STANDARD FIELD SERVICE BULLETIN

FSB Number	CHRAEFSB2016-22 Rev. 1
Author	Tony Bryan
Date	08/30/2016
Subject	Moto G4, Moto G4 Plus - Side-Keys (Stuck / Loose Keys)
Model Affected	XT164x, XT162x
Level Of Repairs	Level 2

Figure 1.0 - Example Stuck Side-Key

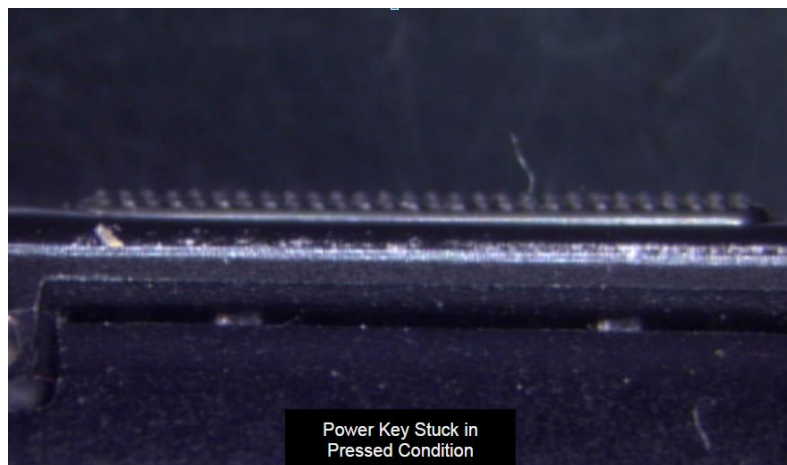
Motorola is aware of a potential customer experience issue on the Moto G4 / Moto G4 Plus products related to Side-Keys. Some users reported experiencing either poor tactile feel (stuck side-keys) or Loose Keys on their Moto G4 / Moto G4 Plus device. See Figure 1.0 below.

1. Stuck Keys: Engineering analysis determined the issue was caused by improper alignment between the side-key buttons and the SMT switches on the PCBA.
2. Loose Keys: Engineering analysis determined this issue was a side-effect of the Stuck

Keys issue above. Key Buttons showed damage indicating user likely picked the key out after it got stuck initially.

Figure 2.0 - Side-Key Kapton Shim Placement

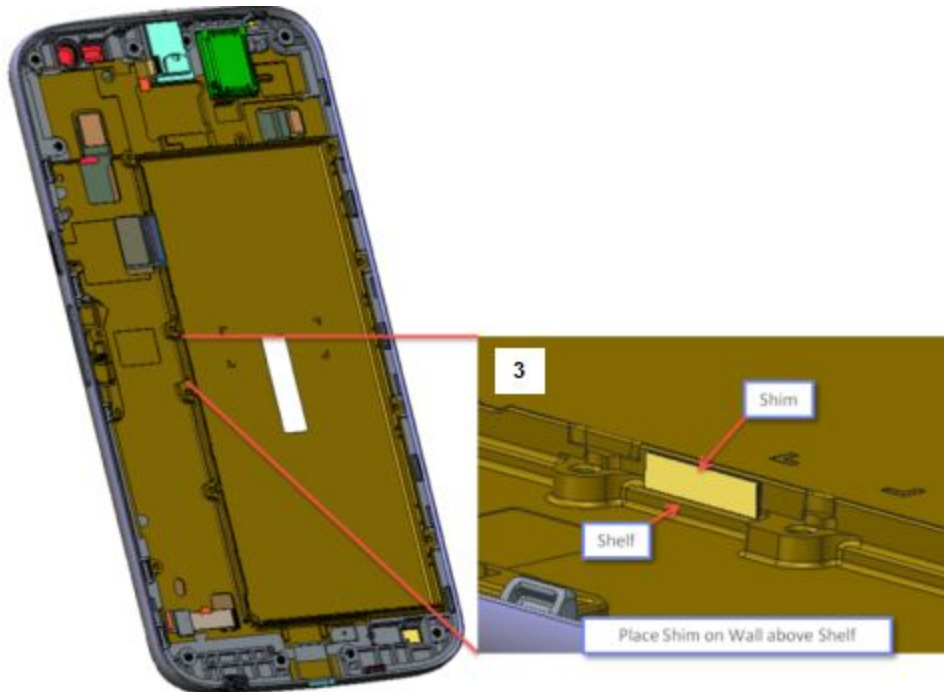
As of 5/31/16, the factory added a Side-Key Kapton Shim (p/n: 11018240001) to the Assembly Process to help better align the side-key button plungers to the SMT switches on the PCBA. See Figure 2.0 below.

Note: Shim must sit above shelf of housing wall and must be hand pressed to achieve good wetting on housing surface.

1. Inspect for and place if necessary the Side-Key Kapton Shim (p/n: 11018240001) prior to reassembly. See Figure 2.0 above.
